Memorandum

To	North Dakota Public Service Commission	Pages	3
Subject	Case Number PU-18-280 Emmons-Logan Wind Energy Center Modifications of Energy Conversion Facility and Site Plan		
From	Emmons-Logan Wind, LLC		
Date	March 17, 2019

**EMMONS-LOGAN
WIND ENERGY CENTER
EMMONS AND LOGAN
COUNTIES, ND**

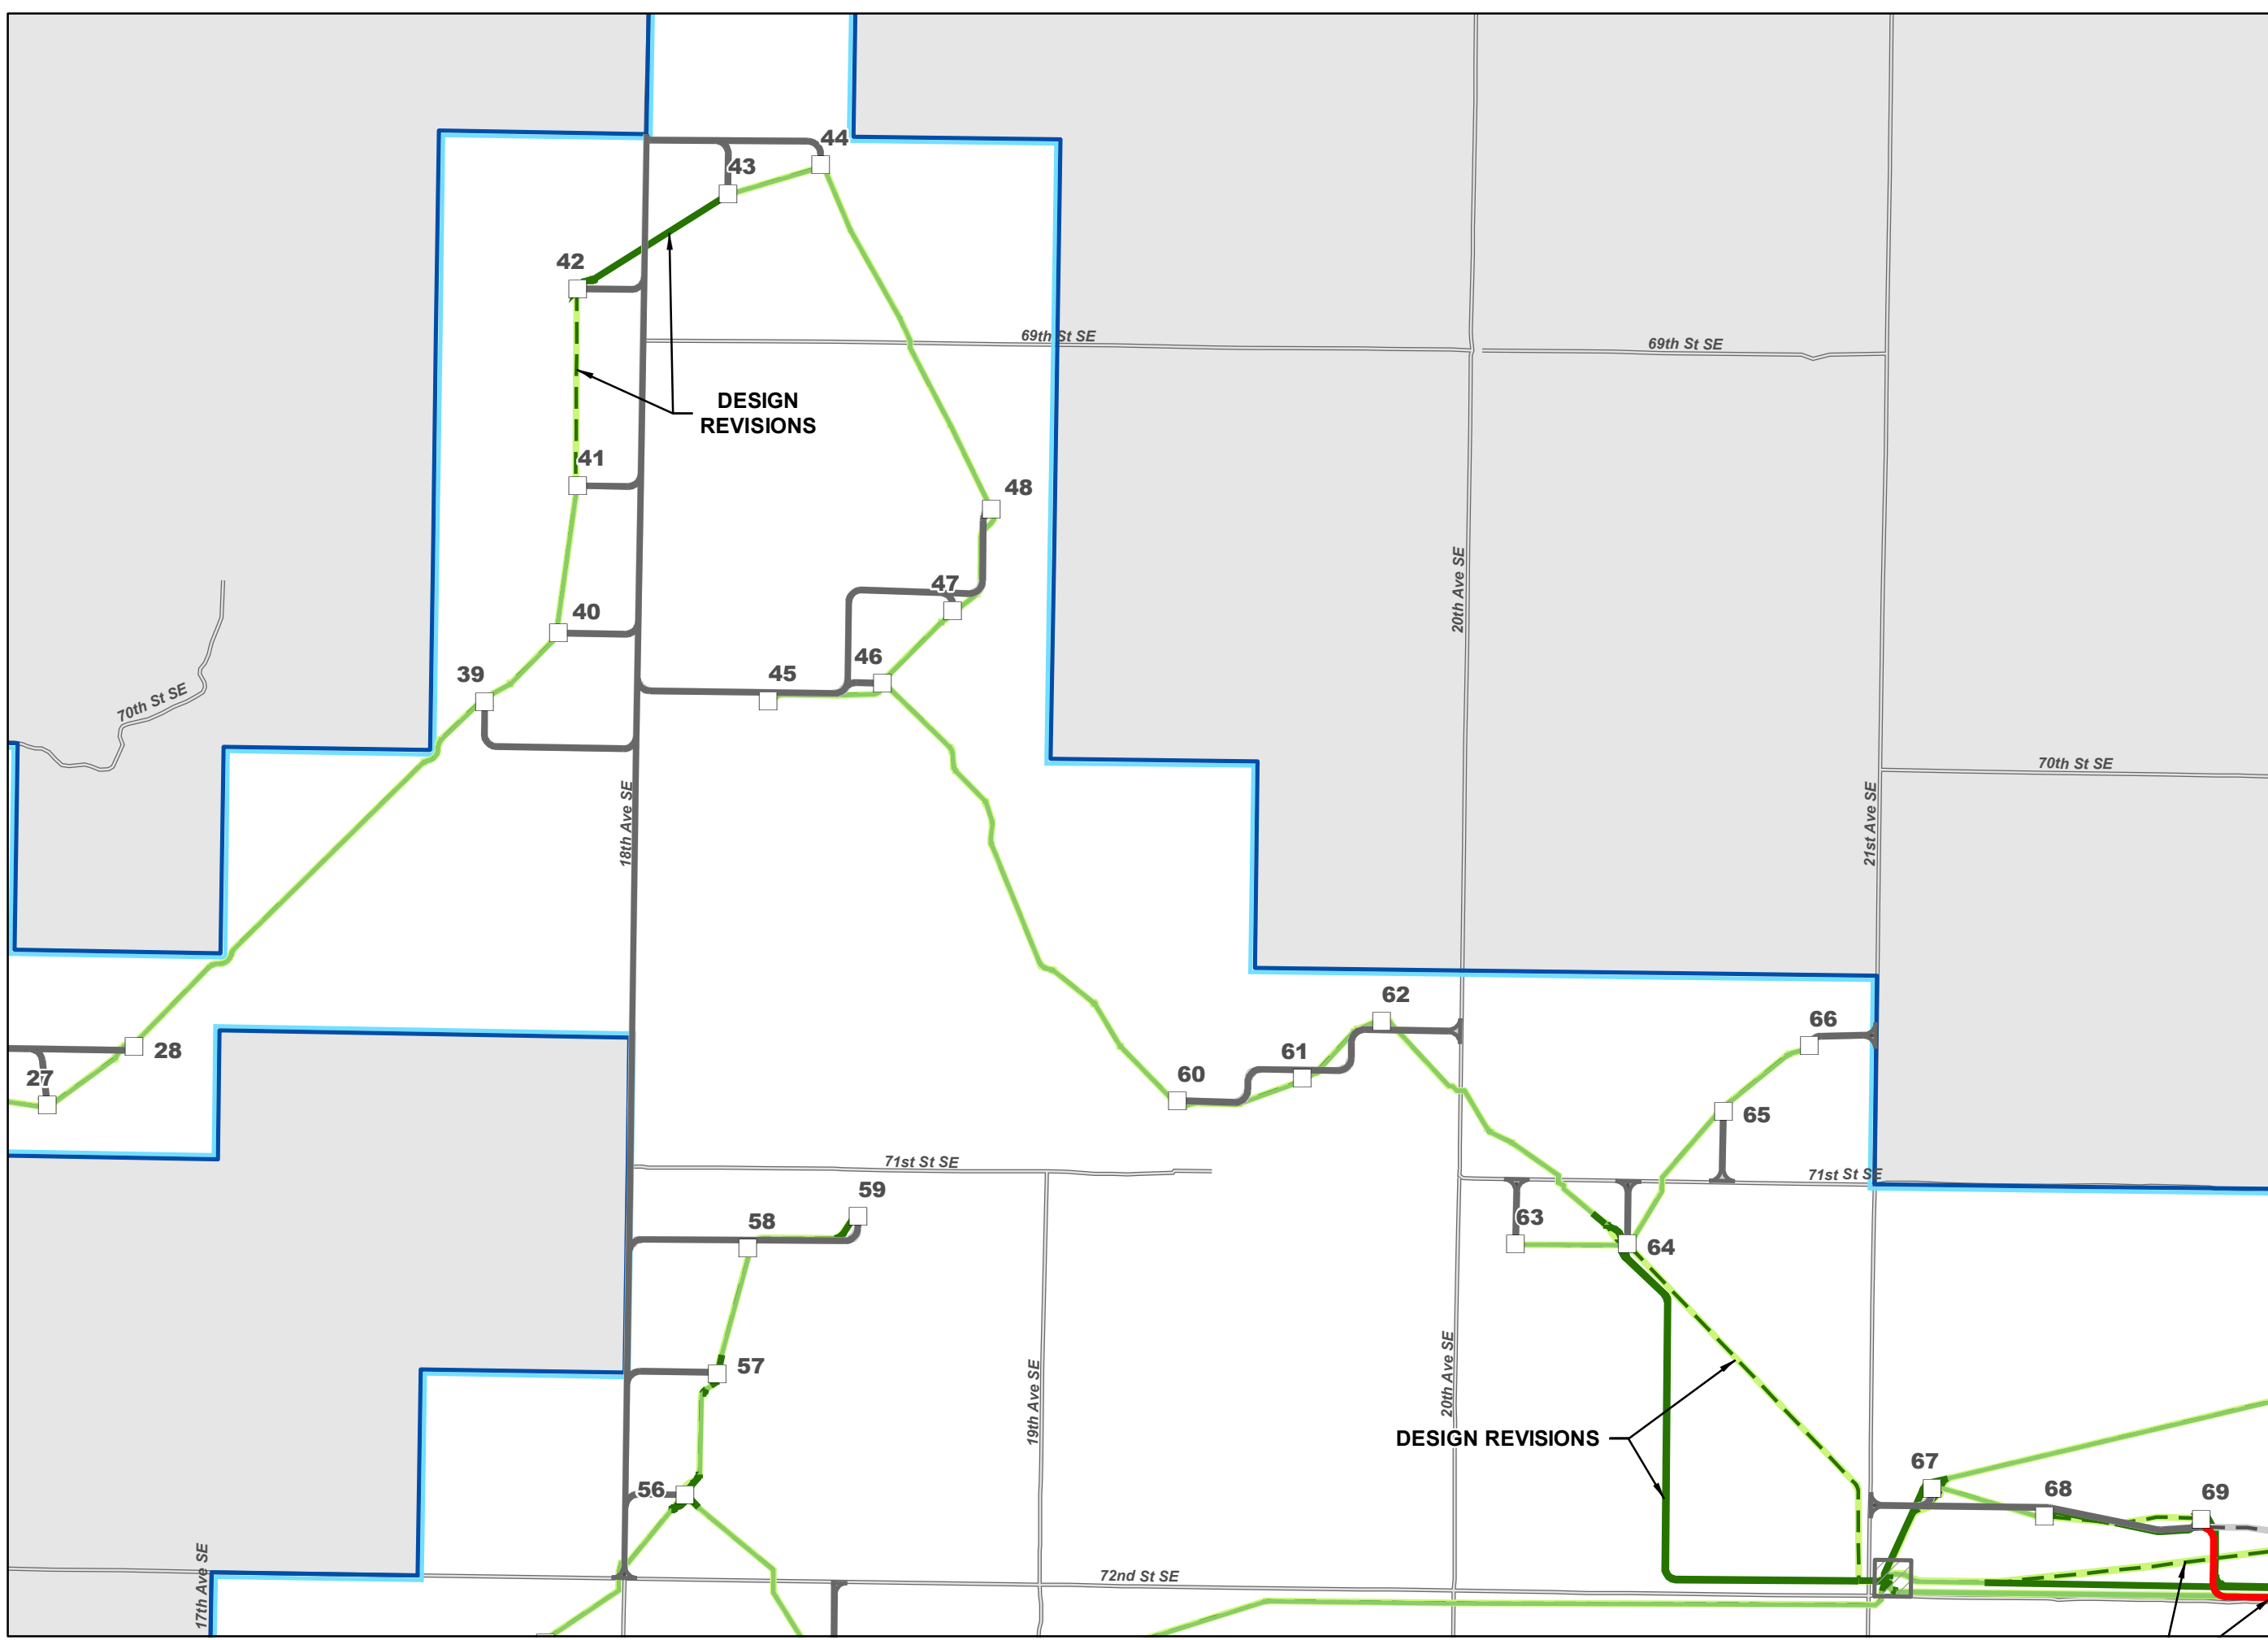
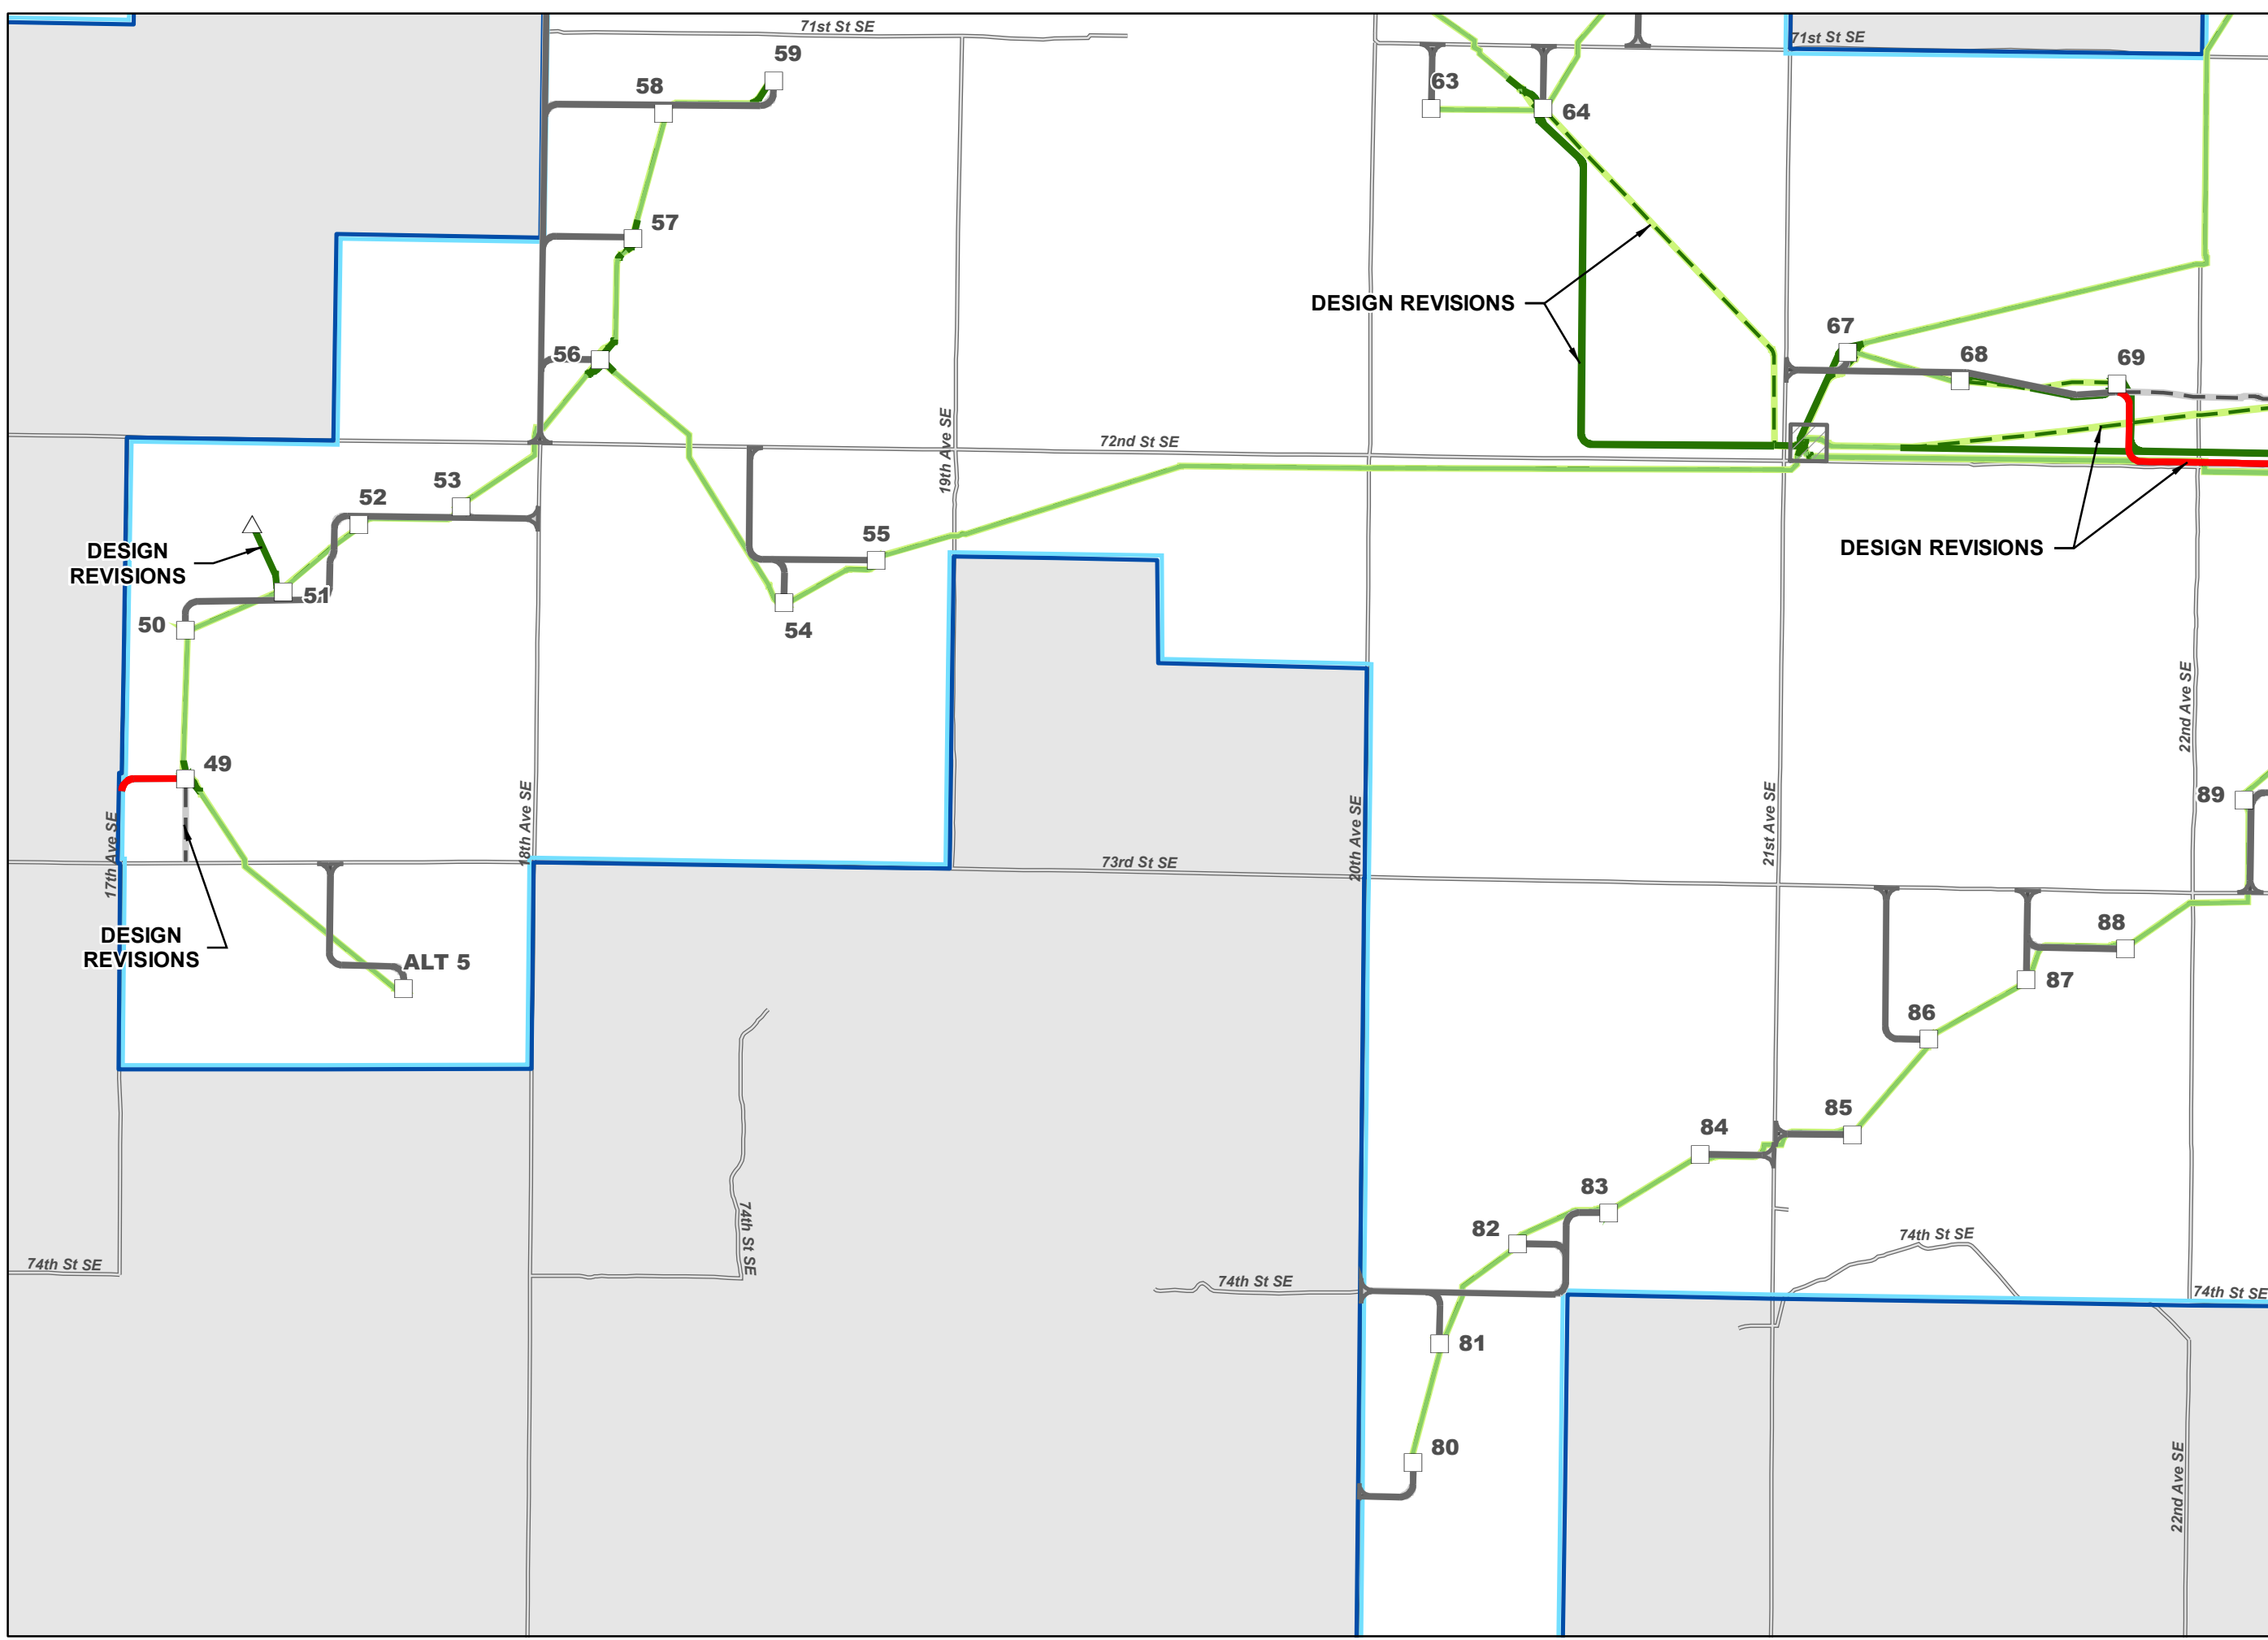
Emmons-Logan Wind proposes certain minor Project Site Plan modifications, including changes to certain collection lines and two access roads. Attachment 4 illustrates locations of the Site Plan modifications, whereas modifications that are imperceptible at the map scale can be viewed using the GIS shapefiles (Attachment 16). Most collection line changes are a result of the turbine model modification, but the collection lines between turbine 64 and the 230 kV substation and between turbine 69 and 93 are a result of landowner requests. This same landowner requested the access road change between turbine 69 and 93 as well. The access road to turbine 49 was also modified to accommodate preferred farming practices of the landowner. Although turbine locations have not changed, new numbers have been designated for most turbines due to the reassignment of proposed and alternative turbines (Attachment 3). The Project Site Plan modifications occur in areas previously surveyed for wetlands, cultural and tribal resources as described below. Attachments 2, 4, and 5 provide updated site plan maps.
